Appendix A: QIA Comments on Baffinland 2025 Annual Monitoring Report

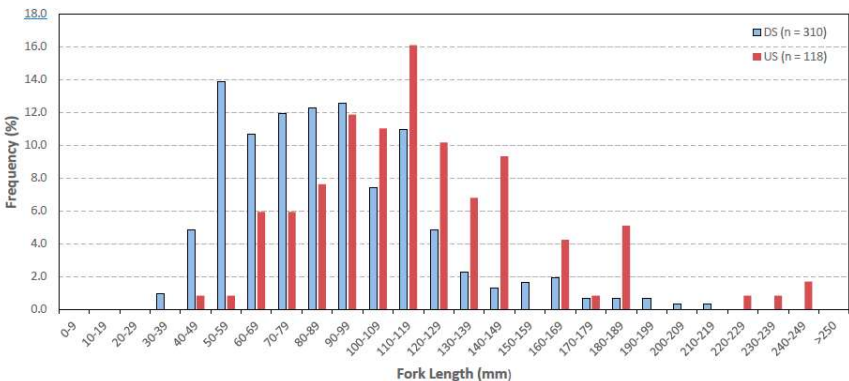
Comment #	QIA 2025 NIRB MAE #2
Subject/Topic:	Ship-board Observer (SBO) Program
References:	Document Name: Baffinland Iron Mines 2025 Annual Report to the Nunavut Impact Review Board PCCs: 103, 106, 107, 108, 123, 73, and 74

QIA Comment	A Ship-board Observer (SBO) program is a key requirement under Project Certificate 005 for monitoring Project interactions with marine mammals and seabirds. The lack of a SBO program, or reasonable alternative, leads to monitoring deficiencies for marine birds (e.g., Project Certificate Term and Condition Nos. 73 and 74, main document s.4.6.9, pp. 243-245; Project Certificate Term and Condition Nos. 107 and 108, main document s.4.6.11, pp. 329-332) and marine mammals (e.g., Project Certificate Term and Condition Nos. 103, 106, 107, 108, 123, main document s.4.6.11, pp. 319-321, 327-332, 362-364). All the issues previously raised by QIA (e.g., in 2025 Annual Report review comments) related to the current lack of a SBO program are still relevant, and the Proponent has yet to establish an alternative. The much larger shipping operation planned along the southern route (compared to the Milne port operation) will increase both the need for SBOs and the value of data collected on vessel interactions with wildlife. The Proponent's support of ECCC seabird research programs is an important contribution to regional research activities, but this work does not support real time monitoring and timely adaptive management, if required. The voluntary Marine Mammal Observation Network (MMON) program provides some data but is not a replacement for trained observers in dedicated monitoring roles. Ten ore carriers participated in the MMON program in 2025 (Appendix G.5.4 - MMON Season Summary), but only two sightings (of 20 individuals) were recorded in the RSA between August and September. One of these observations was reported as a group of 18 North Atlantic right whales (<i>Eubalaena glacialis</i>), which makes three consecutive shipping seasons where MMON vessels have reported species that are not known to occur in north Baffin waters. QIA considers this to most likely be a misidentification of bowhead whales (<i>Balaena mysticetus</i>), but also notes that the North Atlantic right whale is listed as Endangered on Schedule 1 of Canada's <i>Species at Risk Act</i> (SARA). The presence of North Atlantic right whales in the RSA would require significant additional mitigation to ensure shipping operations do not cause harm, so having trained SBOs capable of differentiating the wildlife species present is in the Proponent's best interest. Some degree of training is provided to participating MMON vessels, but it does not appear to be sufficient. Ship-board marine mammal monitoring (visual and acoustic) was conducted during the 2025 multibeam bathymetric survey in Foxe Basin (see Project Certificate Term and Condition No. 123, s.4.6.11, pp. 362-364; Appendix G.8.3 - Bathymetry Survey Operations and MMO Report). Five marine mammal observations (all seals) were reported. This mitigation-based monitoring by SBOs informs the need for shutdowns (etc.), which is necessary, but does not address monitoring requirements for the active Project. With respect to program alternatives, the Proponent indicated (Project Certificate Term and Condition No. 106, main document s.4.6.11, p. 328) that it was "<i>currently exploring all reasonable measures and will provide an update to the Board before the 2026 shipping season</i>" (and discuss in the next Annual

Report) (also see Project Certificate Term and Condition No. 123). Has this update been provided to the Board and posted on the Public Registry? In addition, Baffinland previously committed to providing a summary of Eider species observations since the beginning of the SBO program in future reports (in response to 2023 Annual Report comments – Appendix E.1). Since there is no SBO program, QIA subsequently requested that a standalone summary report of this information be provided instead. In response, Baffinland referred to work being done by ECCC on sea ducks and shorebirds in the arctic.
QIA Conclusion/Request	QIA requests that the Proponent: 1) prioritize submitting the update to the Board that was to be provided in advance of the 2026 shipping season, including possible alternatives to having SBOs on vessels such as, but not limited to, the use of drones (also see Project Certificate Term and Condition No. 107, main document s.4.6.11, pp. 329-330), vessel-mounted cameras, or community-based programs involving harvester observations of marine mammal and seabird responses to vessel transits, and, 2) provide details on the MMON training that is provided to participating vessel operators. 3) we reiterate our request that Baffinland establish its own targeted marine bird monitoring program which includes determination of habitat use, areas and timing of interaction with Project activities, as well as behavioural responses to vessels, during both migration and breeding periods. Additionally, Baffinland should provide a standalone summary of Eider species observations collected for the Project
